proposed elevations

Project
 Proposed Detached Bungalow - Plot 1
 Land Adjacent Longfield House
 Northon's Lane Holbeach
 for DCF Builders Limited

ELEVATIONS

DRG. No. DCF / pl / P1 / 04revA

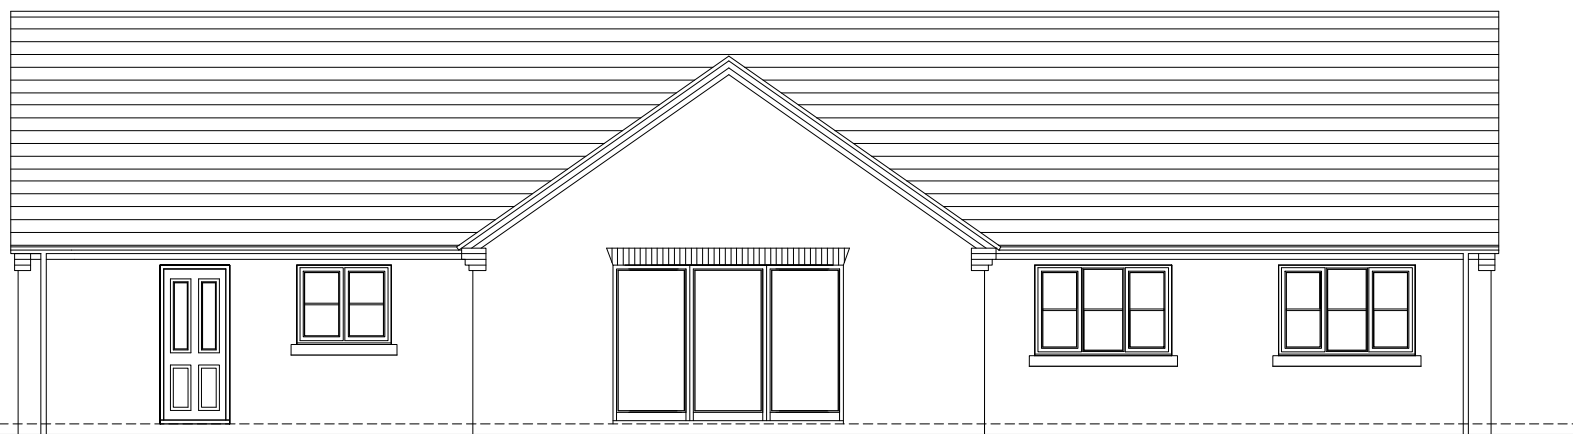
rev A to suit client requirements - nov21
 omit en suite
 larger window to bathroom
 larger windows to kitchen dining
 add window to garage
 enlarge living room
 add fireplace and chimney
 single entrance door & sidelights to front elevation
